FINAL DRAFT MINUTES

September 20, 2012 Standards Committee Meeting

RE: Minutes from the September 20, 2012 Standards Committee Meeting

Figure 404-4D

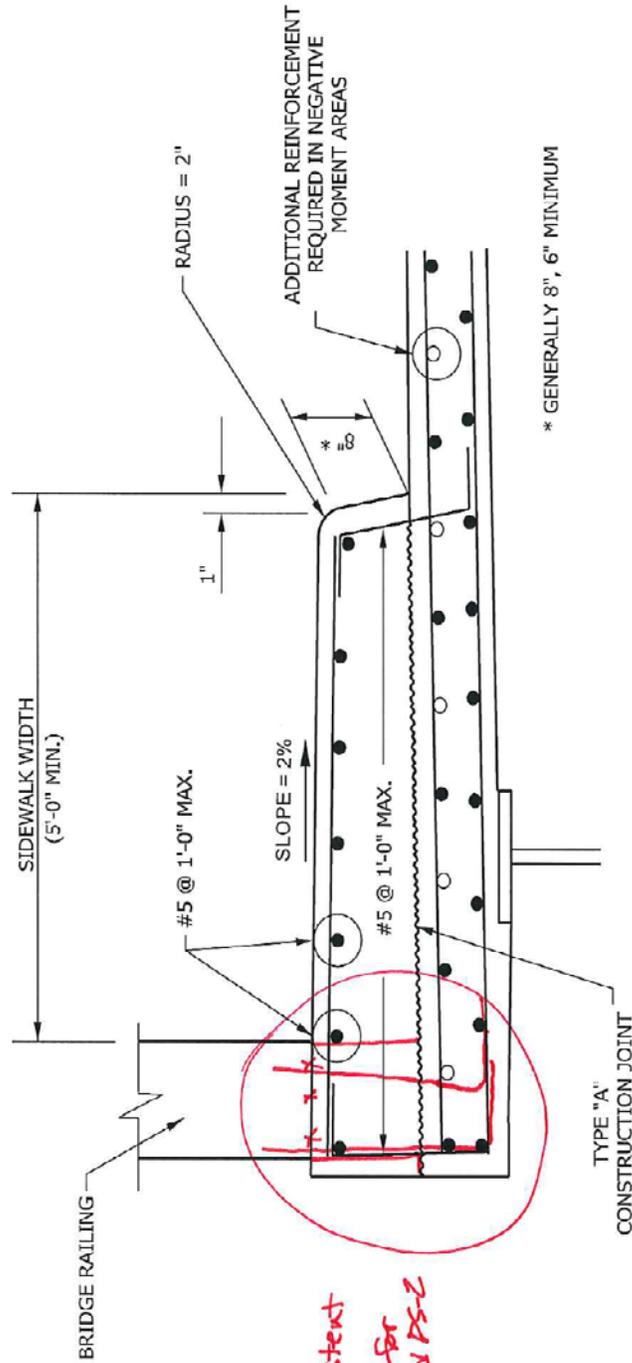
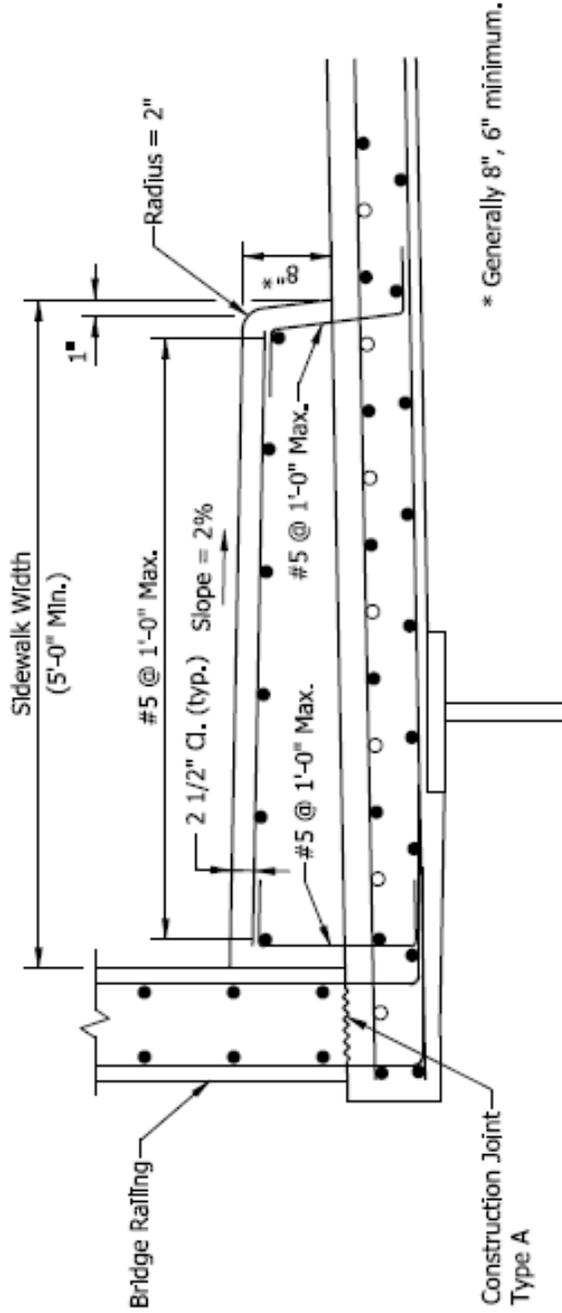
PROBLEM(S) ENCOUNTERED: With the publication of corrected Standard Drawings 706-BRPP-03 and -04, the bridge railing construction shown in Design Manual Figure 404-4D is no longer consistent with the Standard Drawings for pedestrian bridge rail in combination with a concrete sidewalk. The concrete bridge rail should not be shown sitting atop the sidewalk.

PROPOSED SOLUTION: Revise the Design Manual Figure 404-4D for consistency with the pedestrian bridge rail Standard Drawings 706-BRPP-03 and -04. See attached markup and final draft of proposed revised figure.

EXISTING STANDARD DRAWING 802-SNGP-01 SIGN PLACEMENT (WITH MARKUPS)

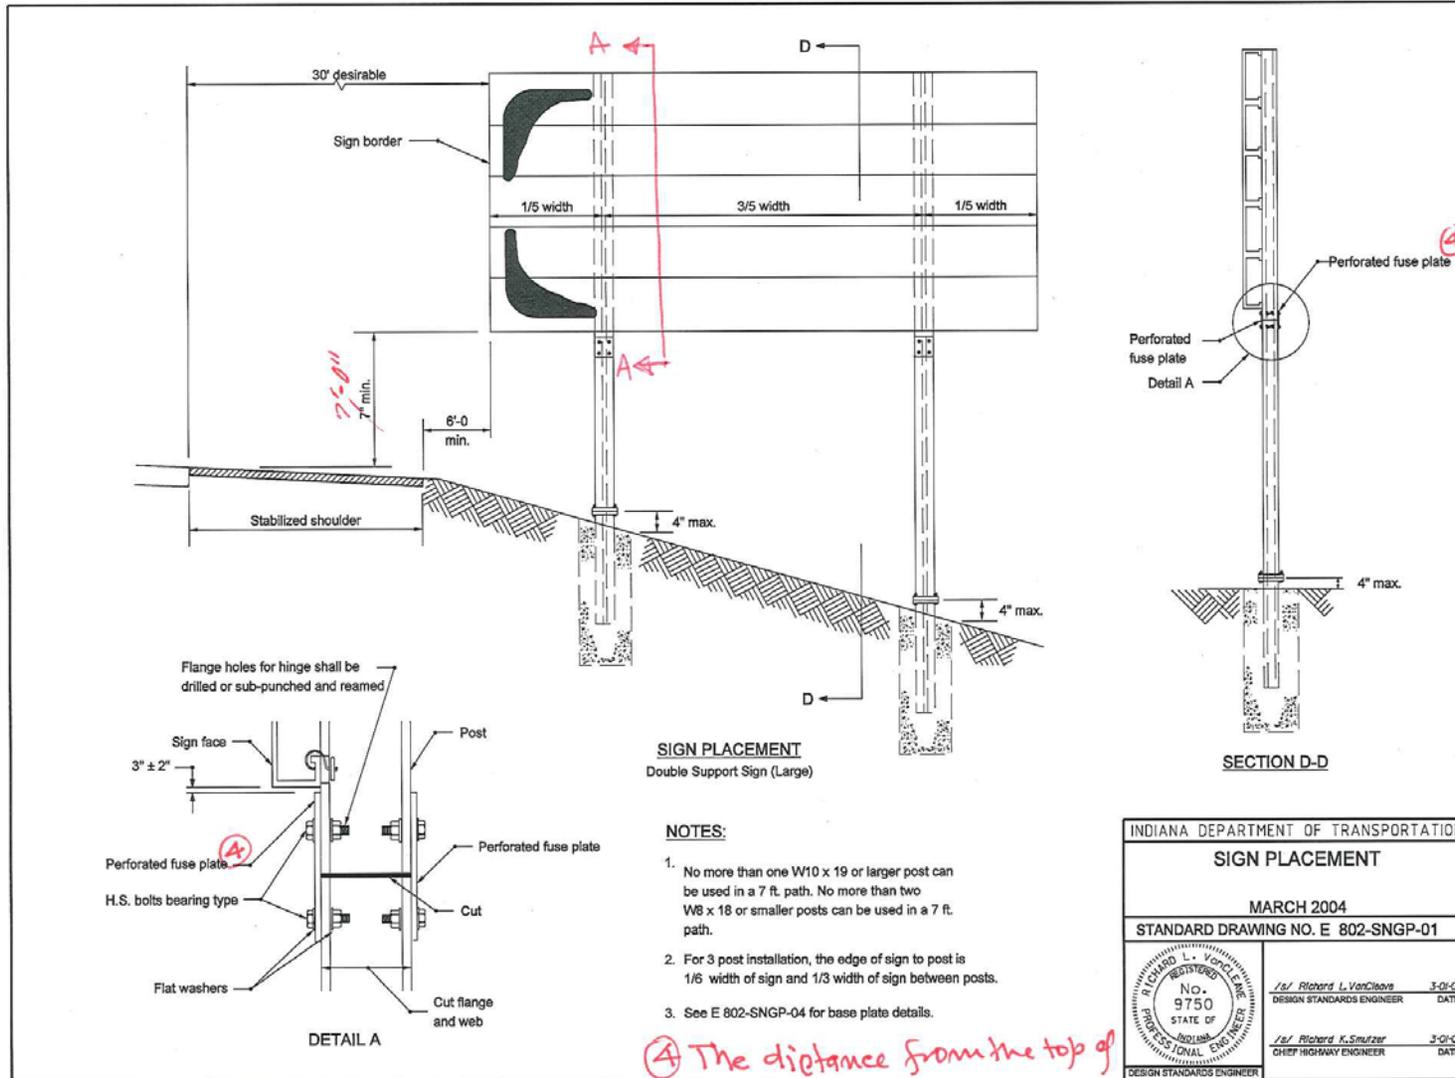
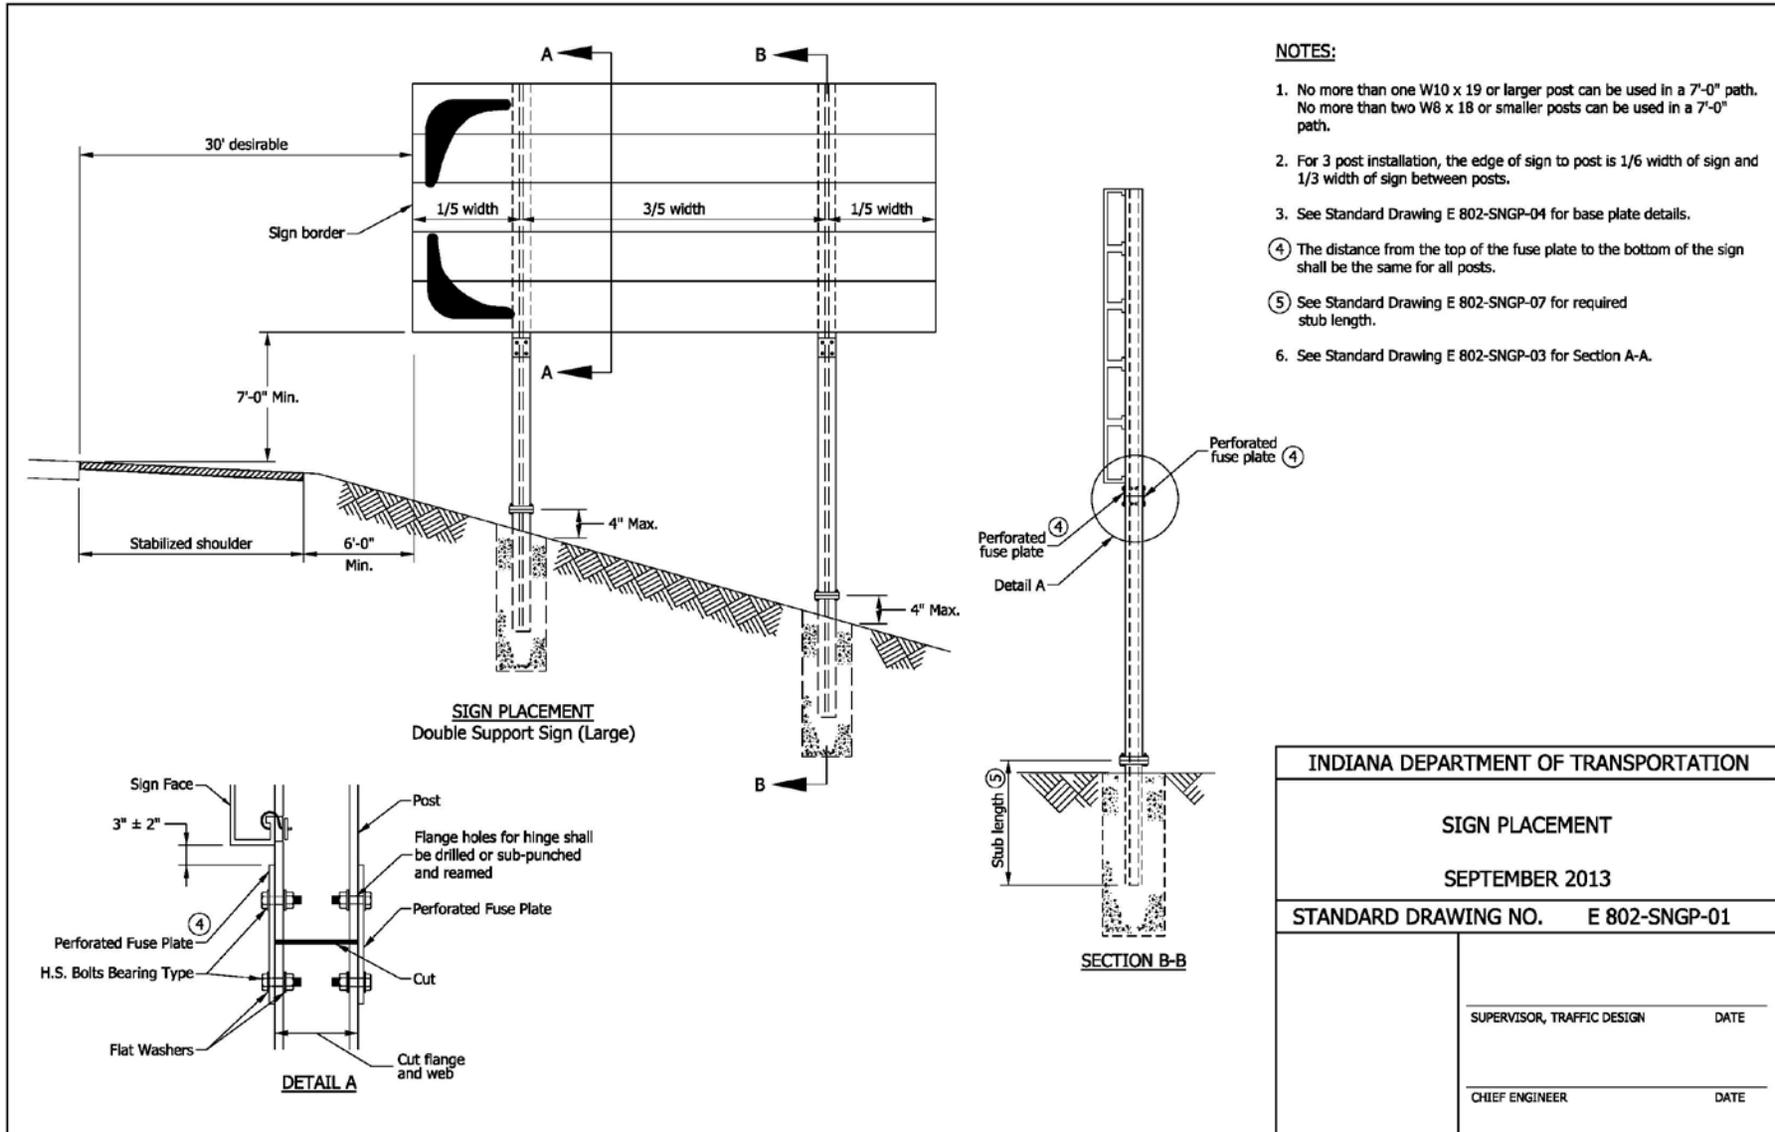
1. On panel sign assemblies the distance between the bottom of the panel sign and the top of the fuse plate often varies from one post to the other in the same assembly. This may lead to the breakaway mechanism not functioning correctly.
2. Clips that attach the sign panel to the support I-beams are not being installed on both sides of the I-beam for signs wider than 24' as they should be. This makes it more likely that the sign will separate from the supports.
3. Standard Drawing 805-SGSP-04 for signal strain poles contains incorrect dimensions for the base plate thickness and anchor bolt hole diameter.

DISCUSSION: Mr. Boruff presented this item as described on the proposal sheet. Mr. Garg stated that at the time of a hit, it would not behave the way it should, so the note was added for clarification.

1. Add a note to Standard drawing 802-SNGP-01 that "The distance from top of the fuse plate to the bottom of the sign shall be the same for all posts"
2. Revise Standard drawing 802-SNGP-03 to indicate that clips on both the left side and right side of the posts are required for signs wider than 24'.
3. Revise Standard drawing 805-SGSP-04 by correcting the anchor bolt hole diameter to 2 1/2" (currently shown as 2") and the base plate thickness to 2 1/2" (also currently shown as 2").

④ The distance from the top of the fuse plate to the bottom of the sign shall be the same for all posts.

EXISTING STANDARD DRAWING 802-SNGP-03 SIGN PANEL DETAILS (WITH MARKUPS)

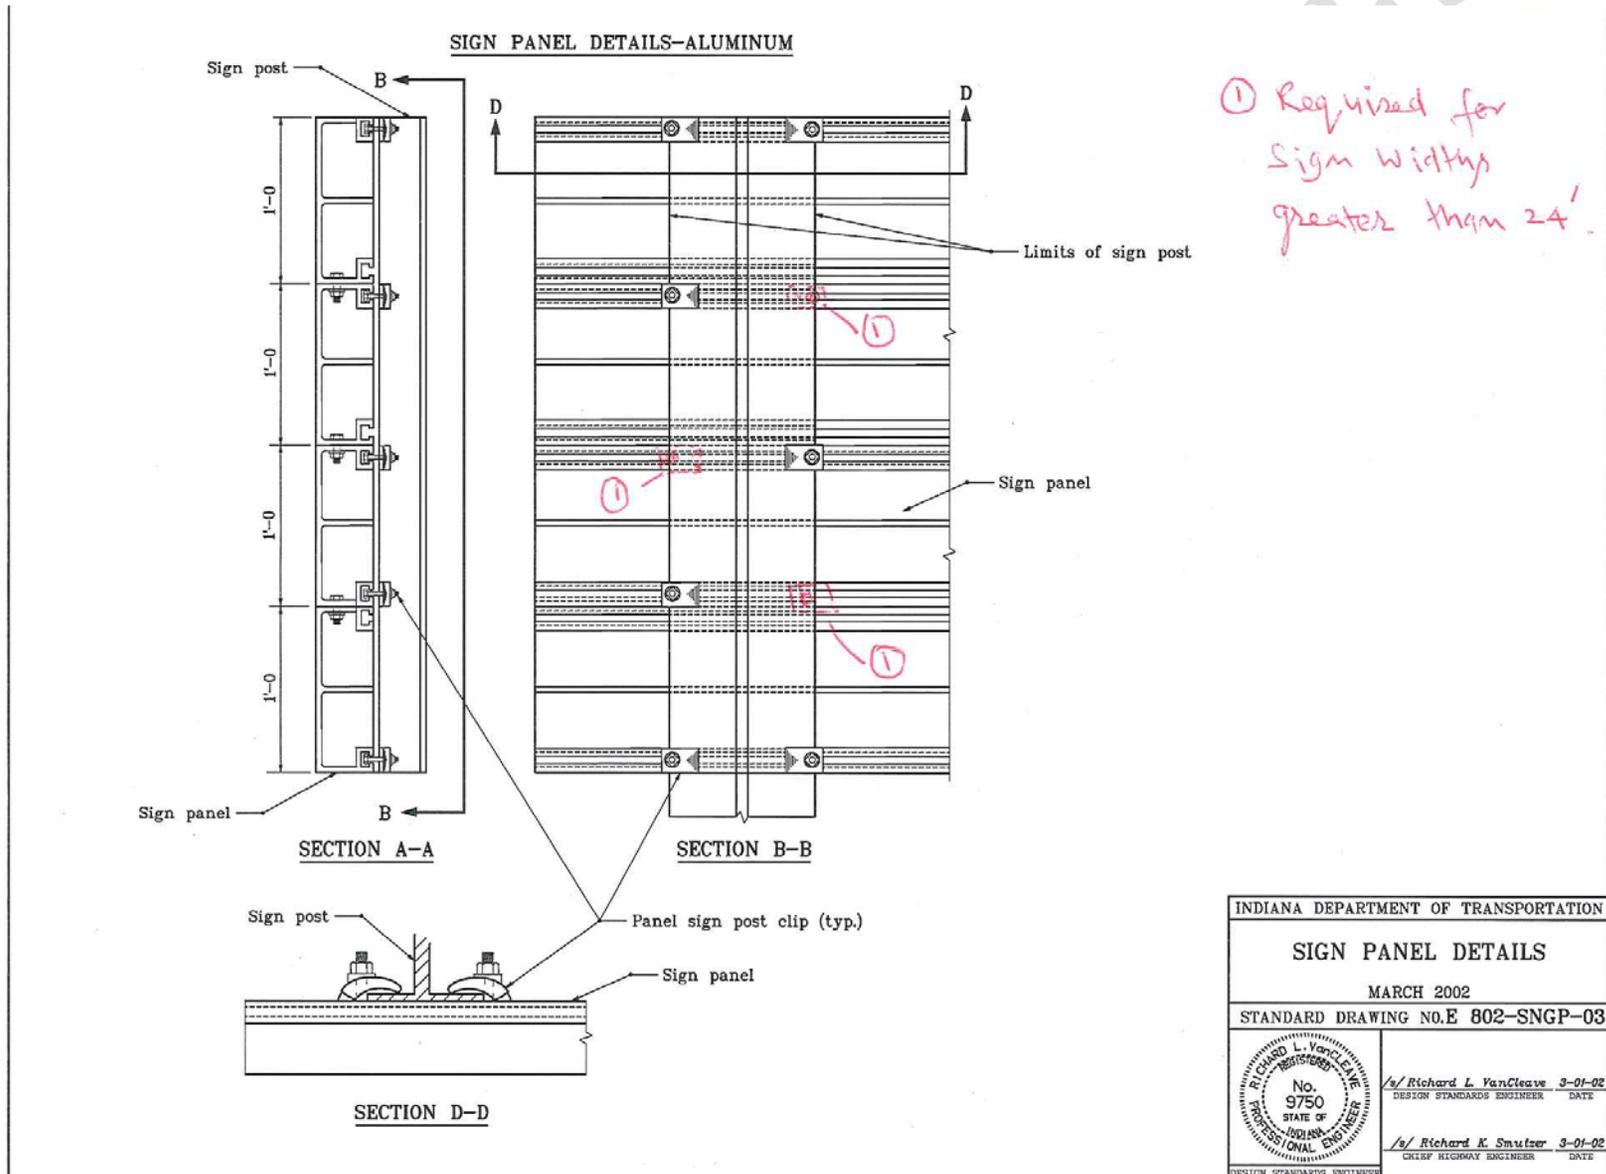
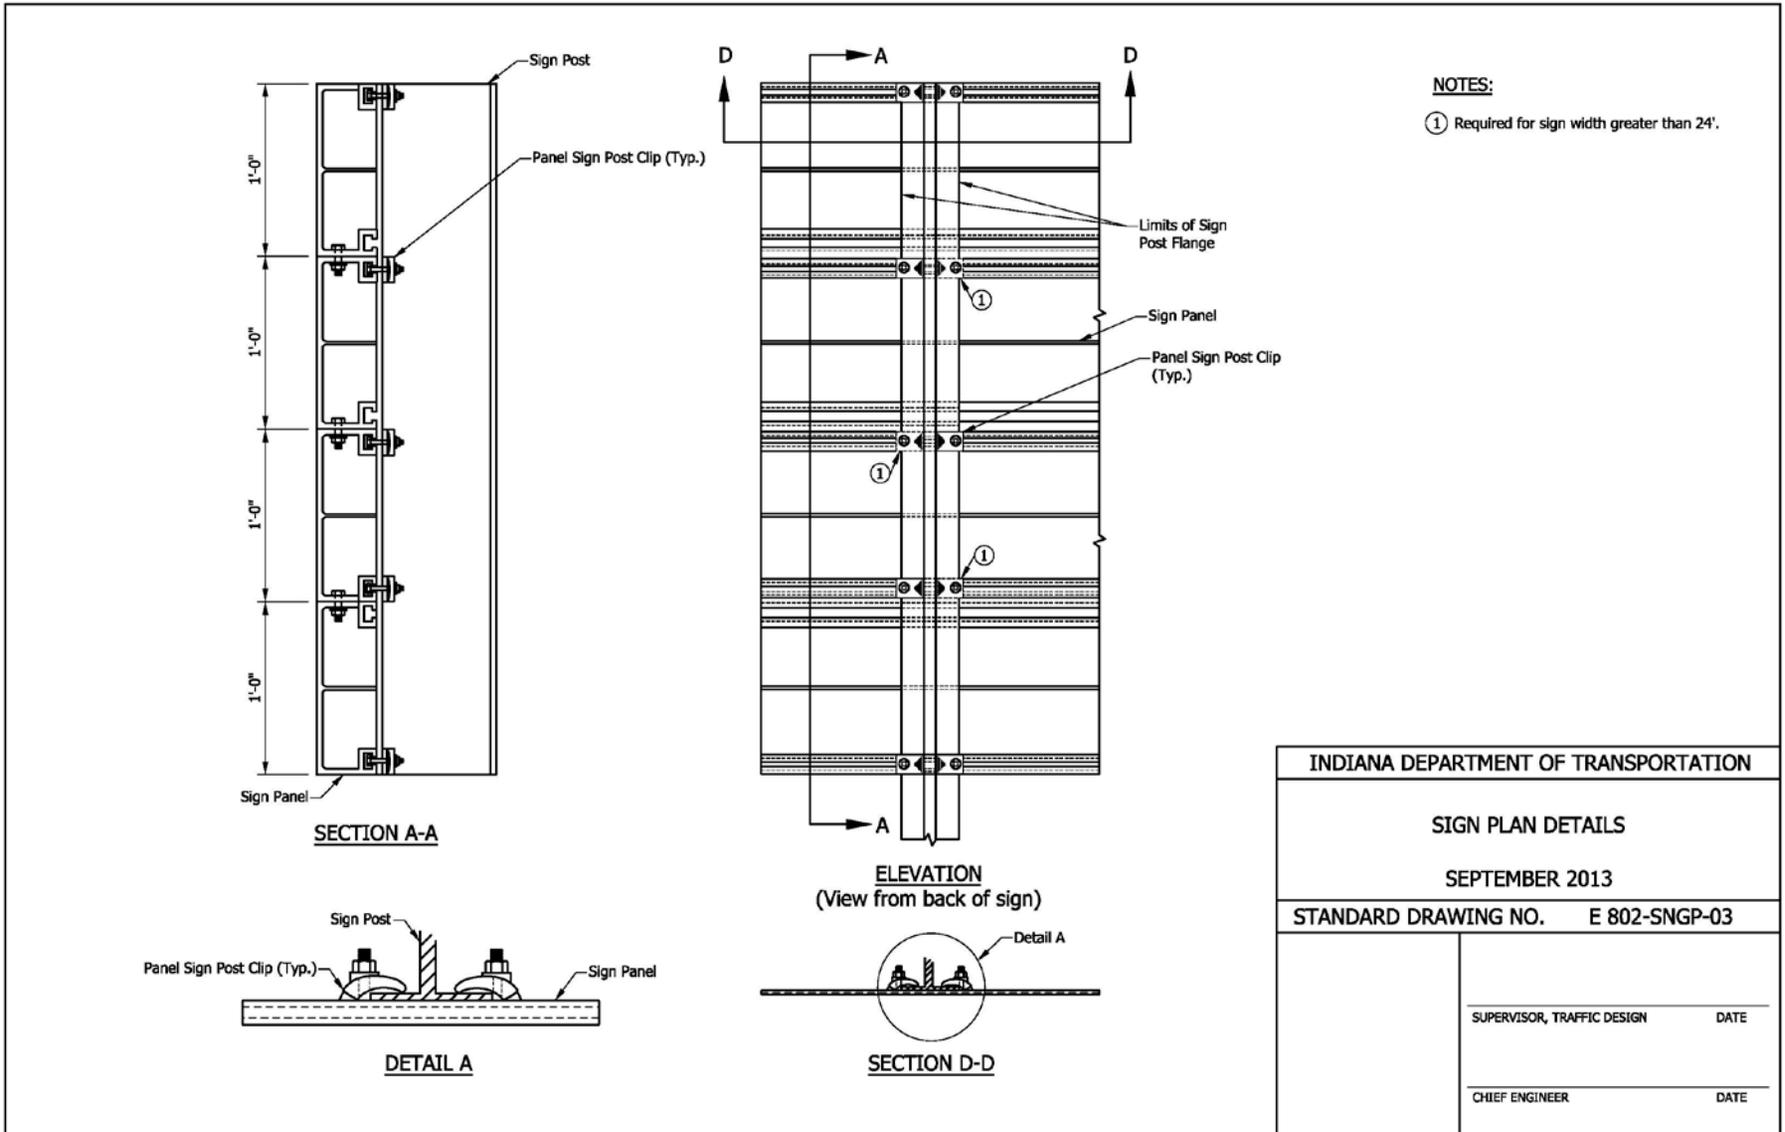
Mr. Boruff continued his explanation of the drawing revisions in regards to clips. Mr. Pankow inquired about the size of the signs and how this applies. Mr. Miller expressed concerns about signs that have blown down following heavy storms. Mr. Garg said that is due to the design of the fuse plate, and they are looking into revising that plate, due to the fatigue on that fuse plate.
